Product Change Notification

113295 - 00

Change Notification #: 113295 - 00
Change Title: Intel® Server System R2308BB4GC
PCN 113295-00, Product Design
Update the System Rear Panel, Resistors and
Capacitor
Date of Publication: October 13, 2014

Figure 1

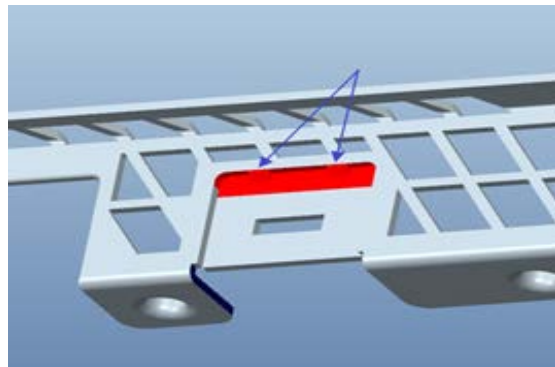
1. Update the one big center joint to two smaller joints so that the joints will not conflict with the LAN cable connector latch. See Figure 1.

Figure 2

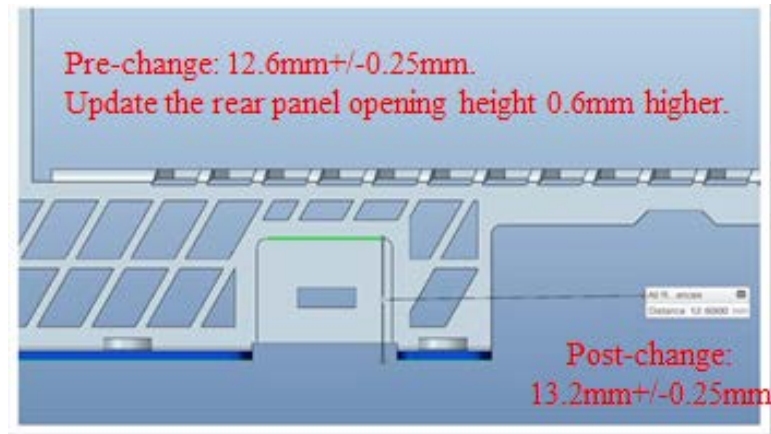
- Update the rear panel opening height 0.6mm higher to improve the flexibility for the cable latch. The previous height was 12.6mm \pm 0.25mm. The updated height is 13.2mm \pm 0.25mm. See Figure 2.

Figure 3

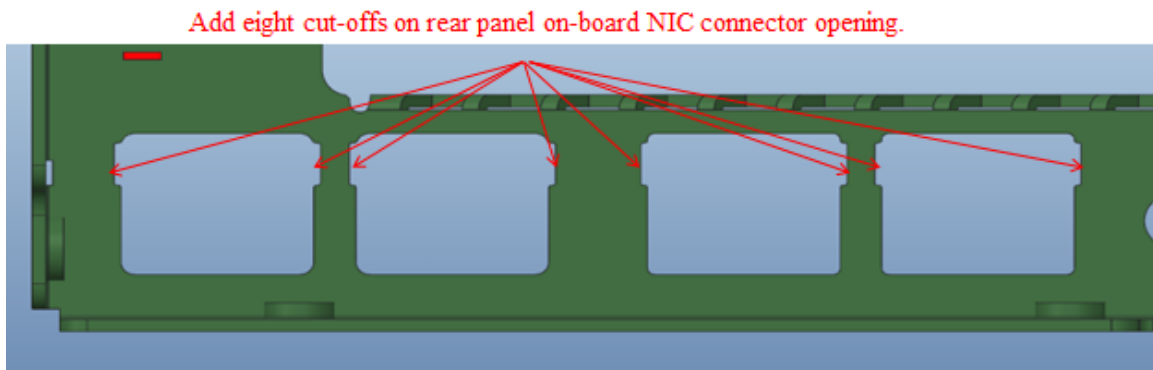
- Add eight cut-offs around the on-board NIC (Network Interface Controller) openings to improve the LED visibility. See Figure 3.

Figure 4. Component Locations for the 2U Riser Spare A2UL8RISER

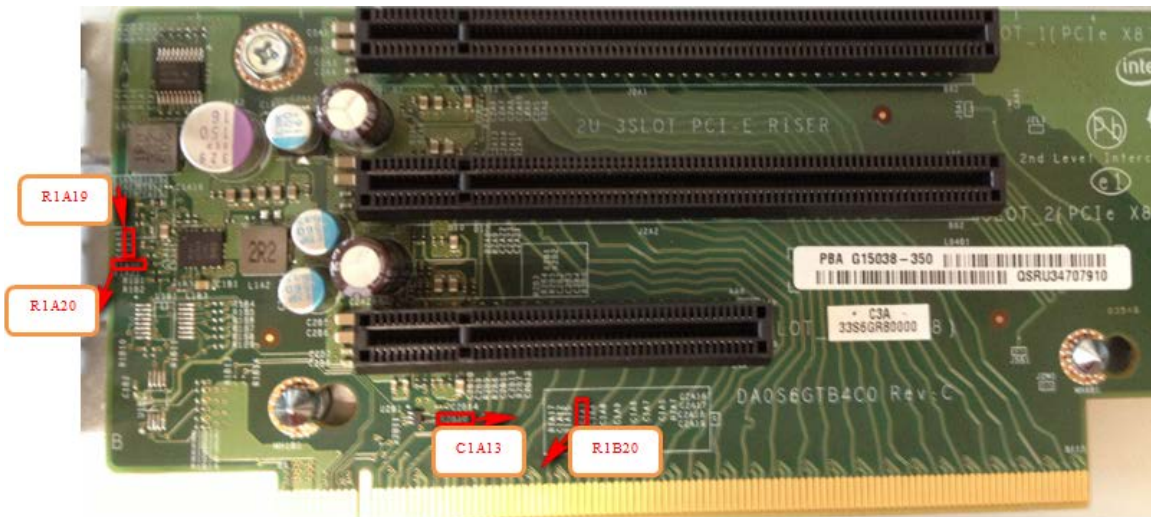
- Update the following resistors and capacitor (see Table 1 and Figure 4) on the 2U PCIe Riser Spare A2UL8RISER to make an improvement to support a higher 3.3 Voltage Regulator startup over current. Before this change, the Voltage Regulator on the riser card may not be able to turn on when the total current drawn is more than 5A current. After this change, the Voltage Regulator on the riser card can support more than 10A current.

Component	Location	Pre-change	Post-change
Resistor	R1B20	10.0 kOhm	3.65 kOhm
Resistor	R1A20	0 Ohm	30 Ohm
Resistor	R1A19	40.2 kOhm	20 kOhm
Capacitor	C1A13	10 pF	120 pF
